SUBJECT: Quail Ridge Addition Comments DATE: 7/27/84

Re: Quail Ridge Addition

PRELIMINARY PLAT
QUAIL RIDGE ADDITION
 CITY OF ROCKWALL
 ROCKWALL COUNTY, TEXAS

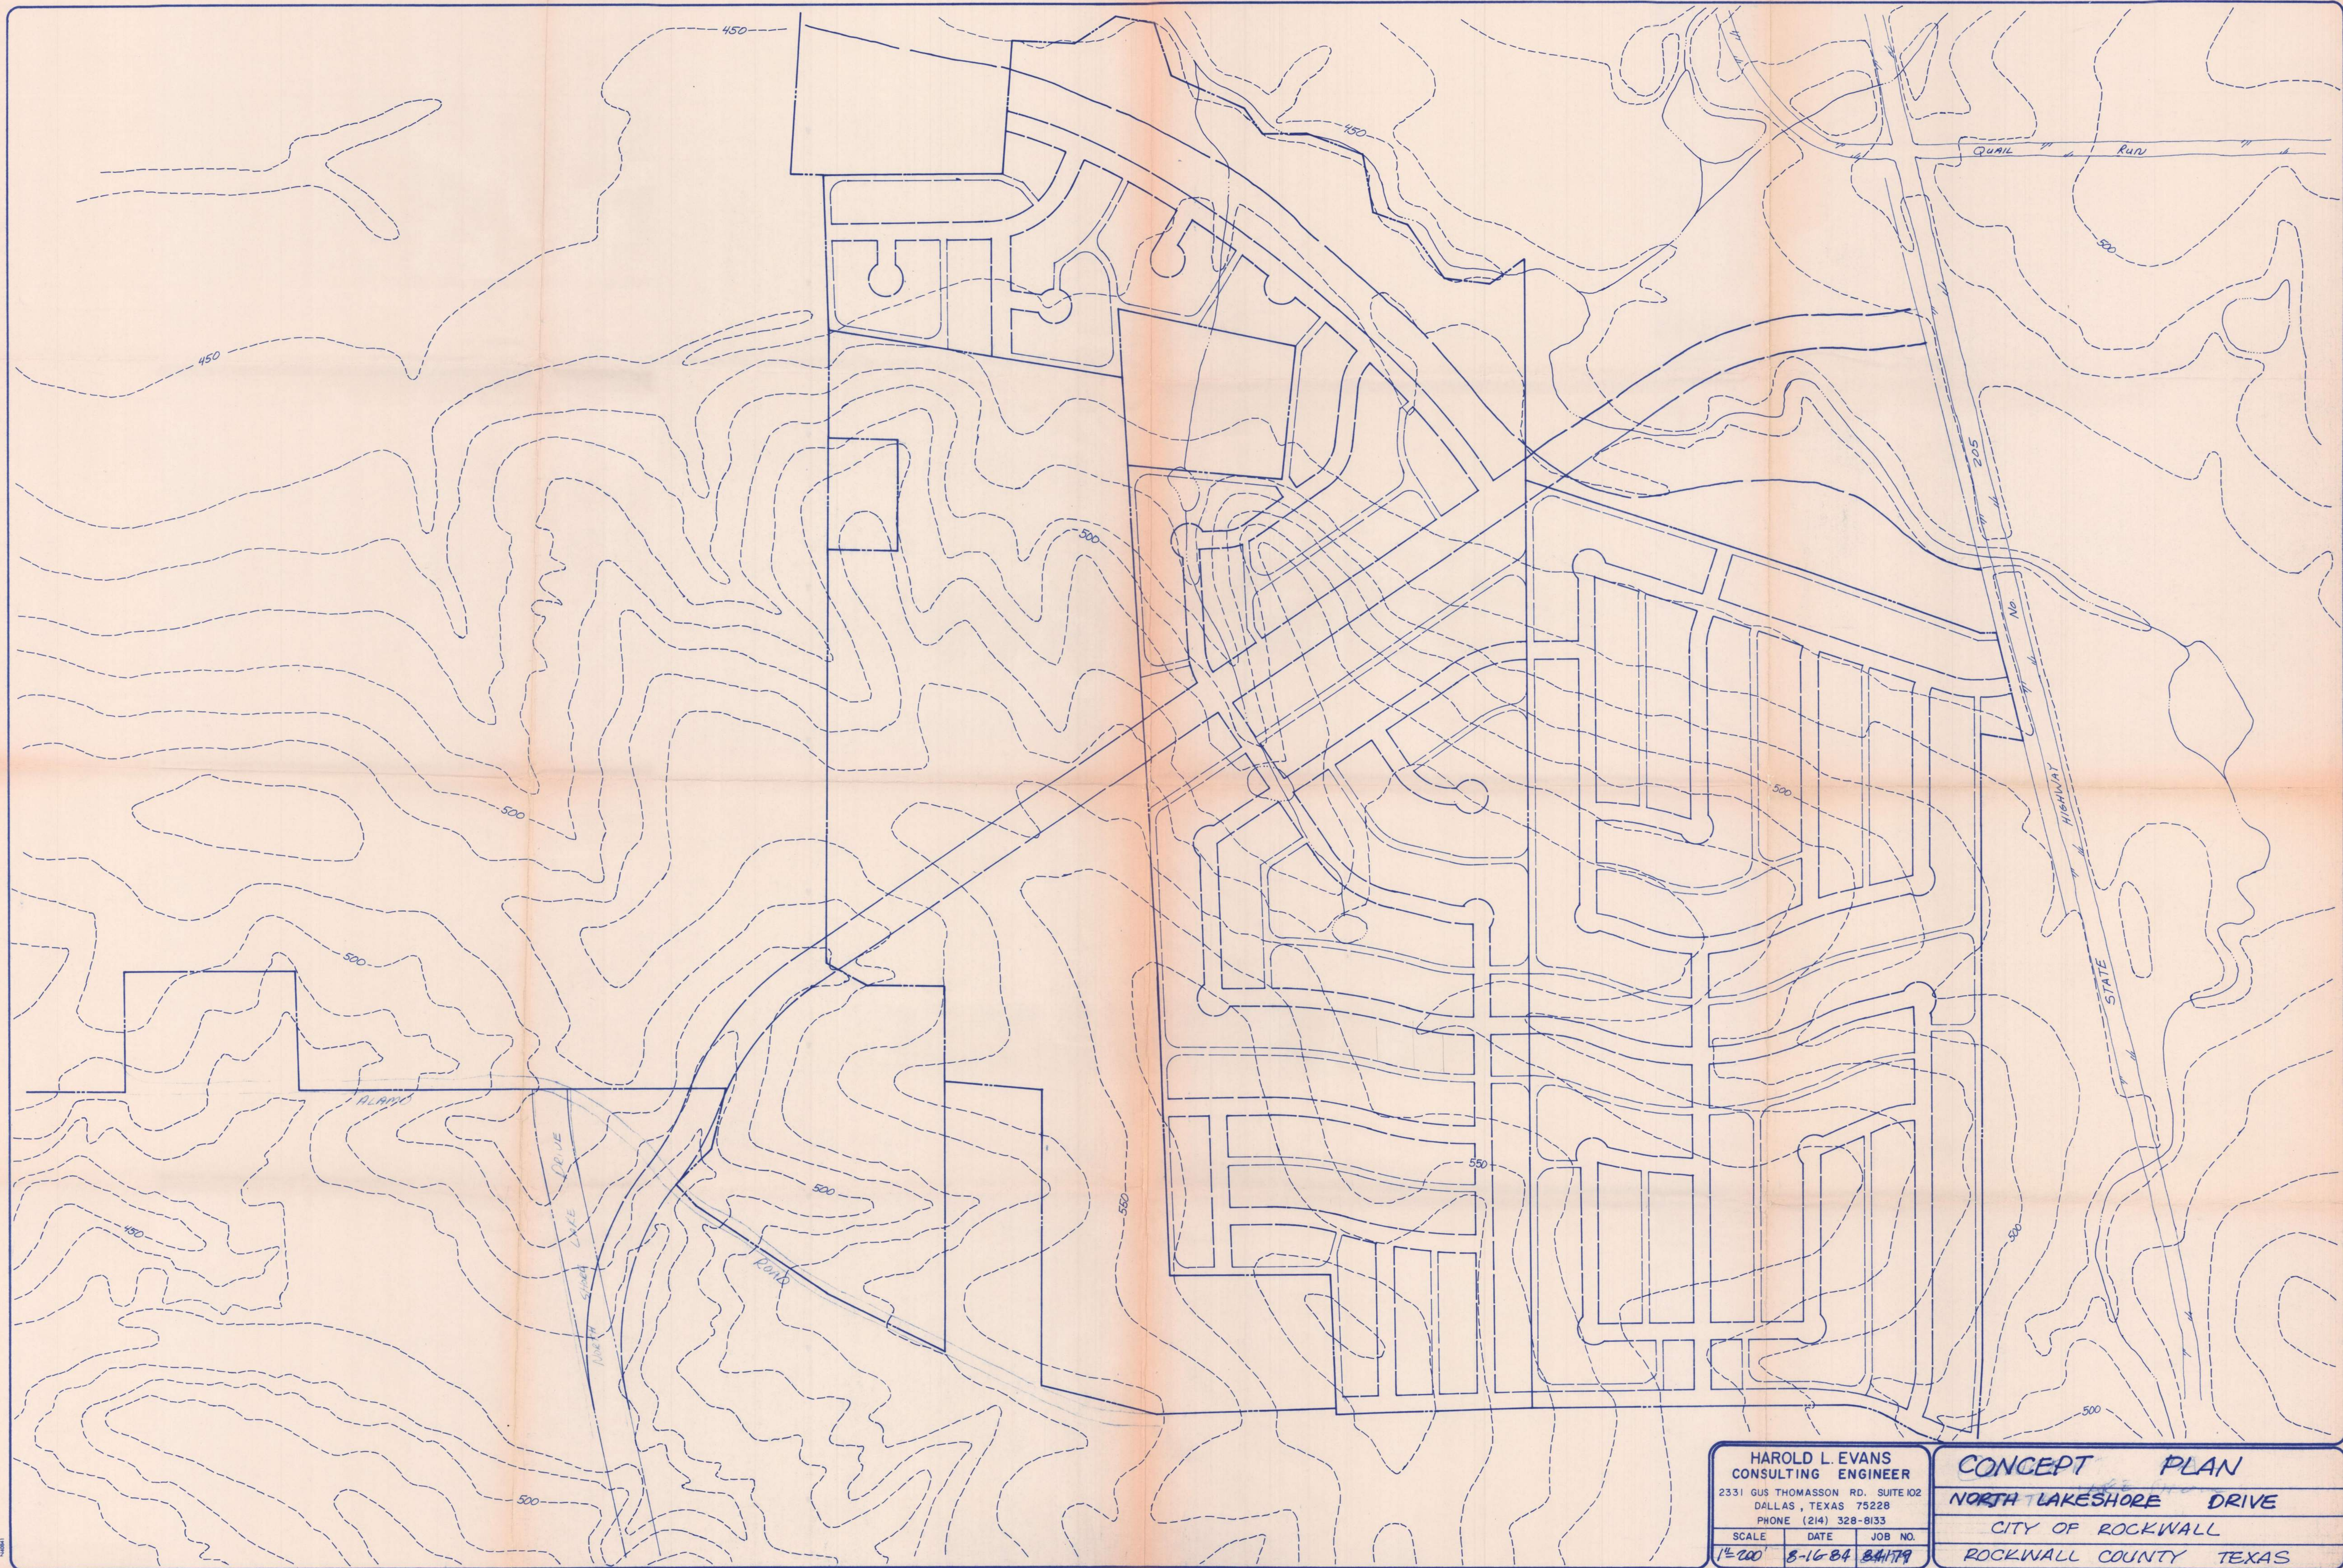
In response to your letter regarding the Quail Ridge Addition preliminary plat (July 27, 1984), the applicant should be requested to complete a route study of the North Lakeshore Drive extension at the present time. This study is necessary, since a portion of the subject tract may be directly affected by the final alignment of North Lakeshore Drive.

In addition, based on trip generation, site access and the layout of the proposed development, Alamo Road should be improved and straightened into S.H.-205 concurrent with construction of the southern half of the subdivision. These roadway improvements should correspond to the roadway classifications and alignments reflected in the Rockwall Thoroughfare Plan.

CONCEPT PLAN
NORTH LAKESHORE DRIVE
 CITY OF ROCKWALL
 ROCKWALL COUNTY TEXAS

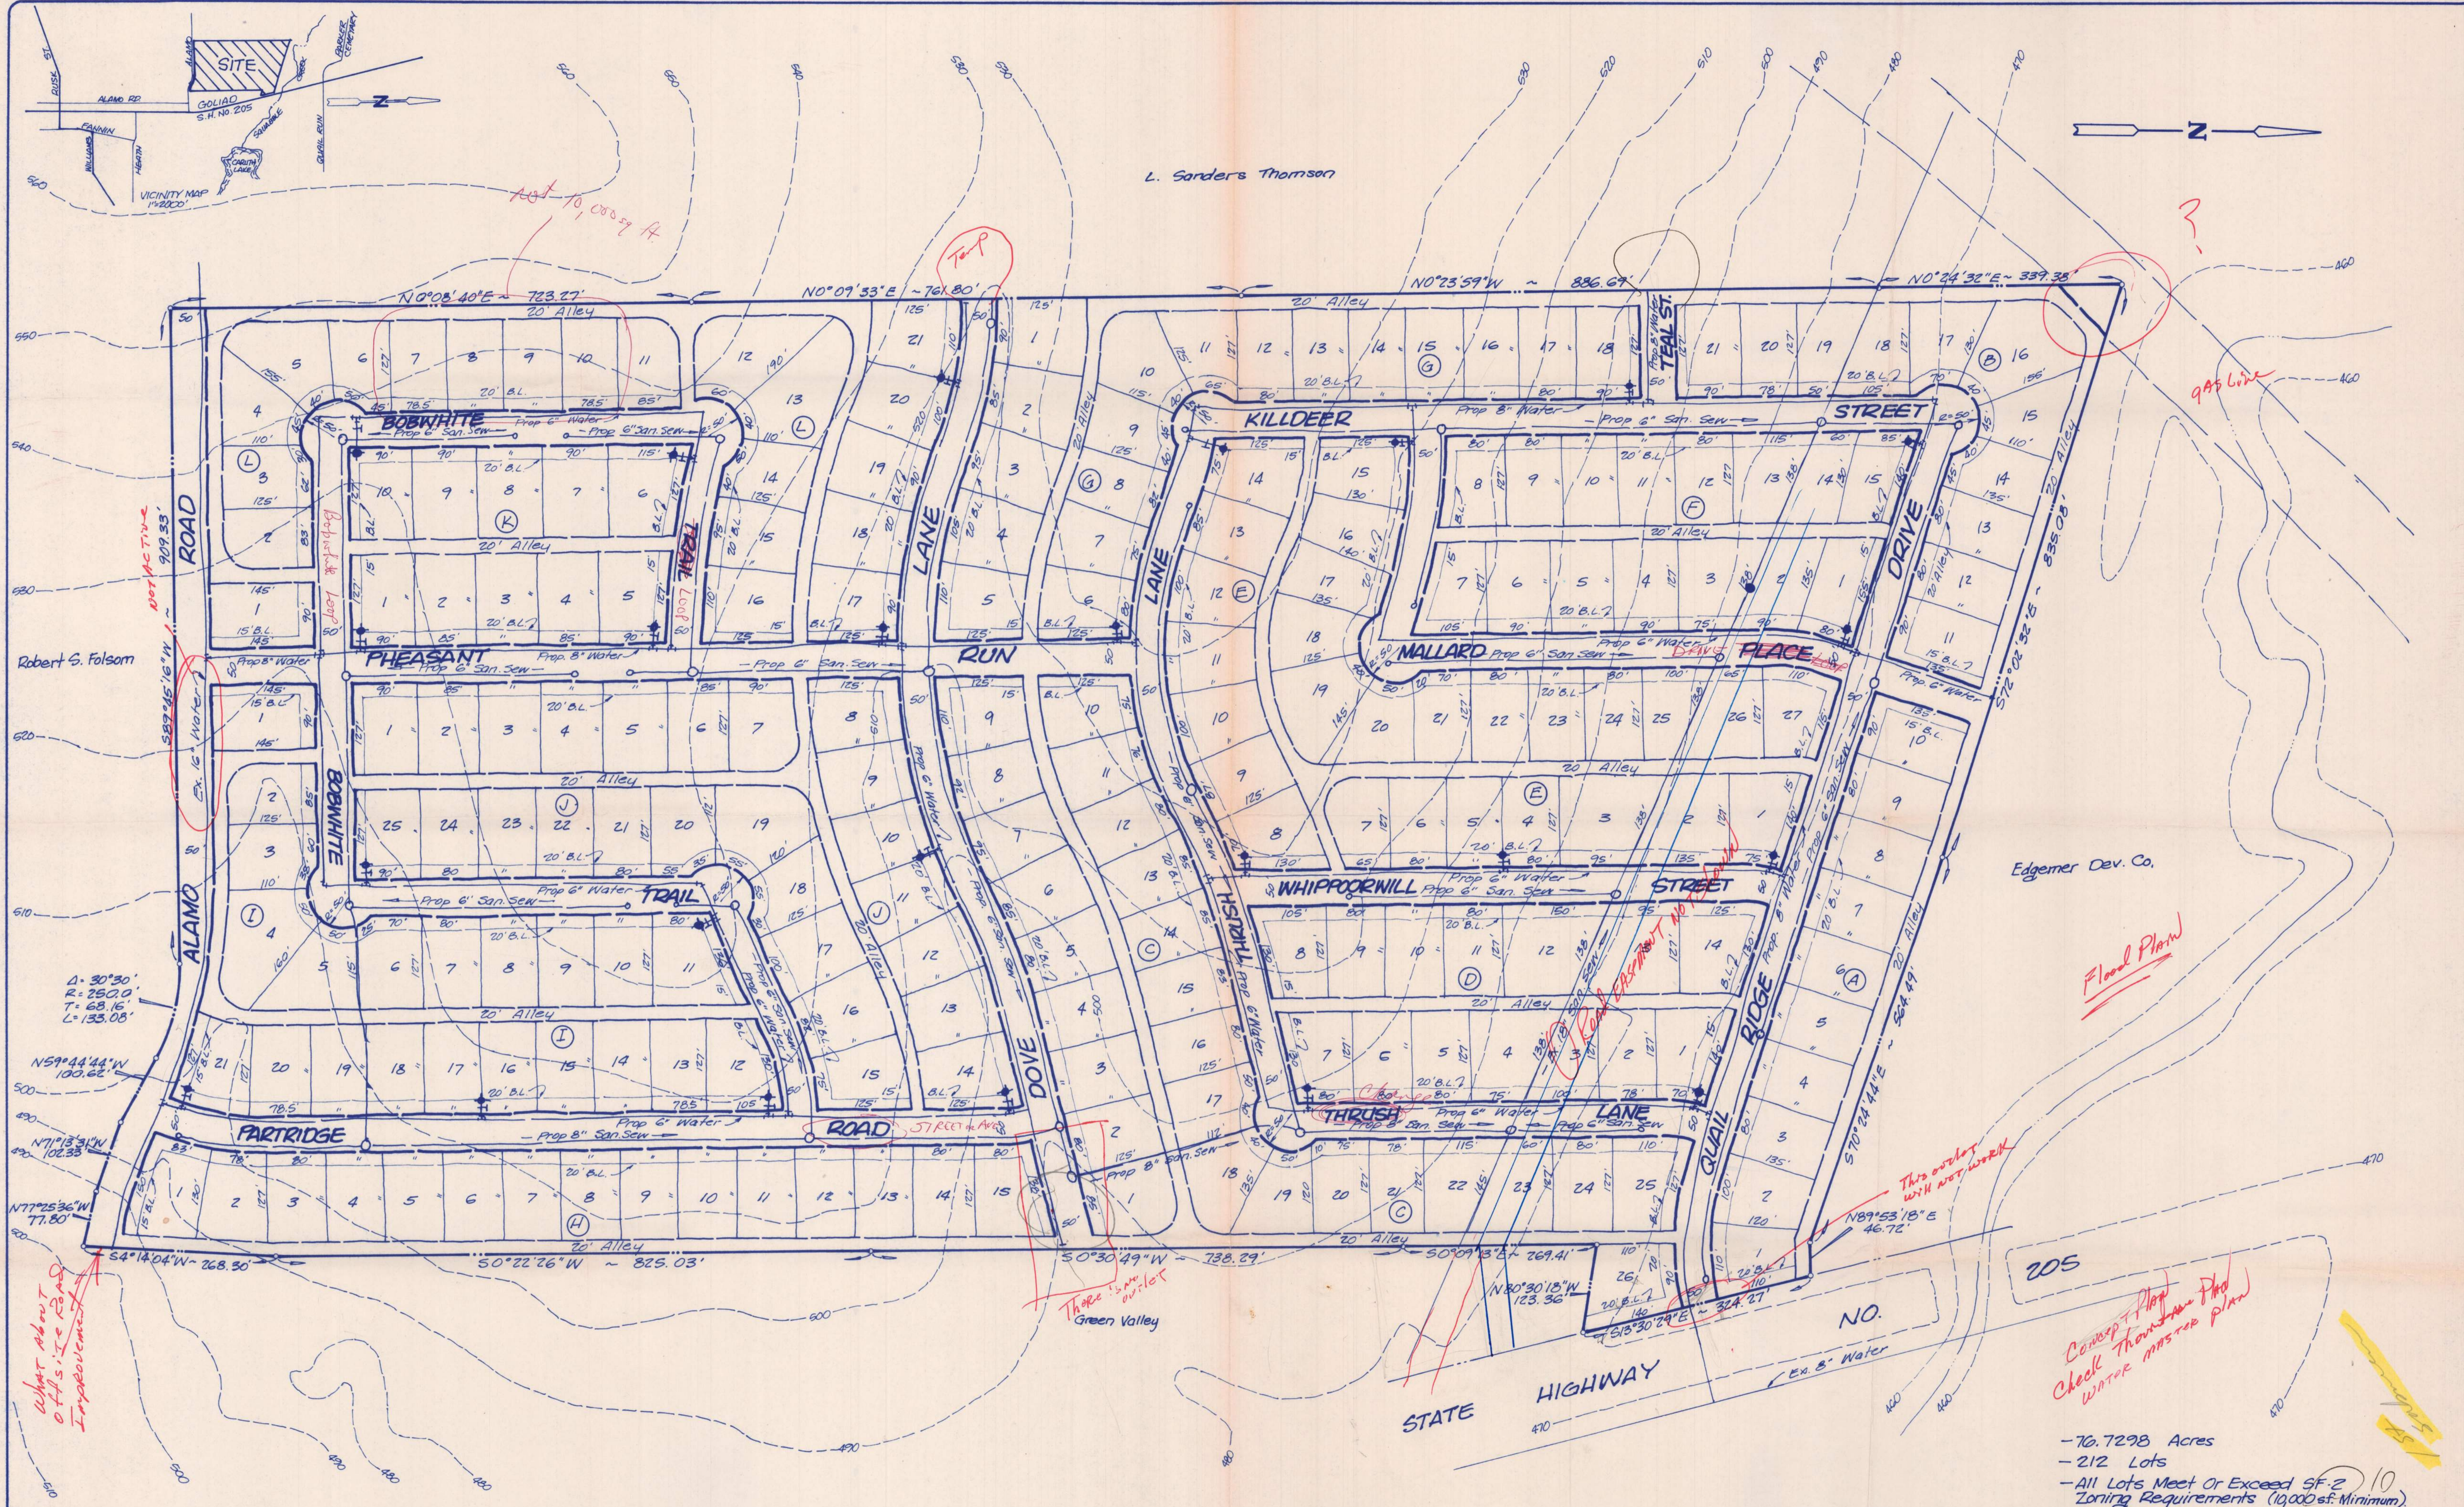
This overlay will not work

There is an outlet Green Valley

What about off-site Road Improvement?

Concept Plan Check Thomson Flood Water Master Plan
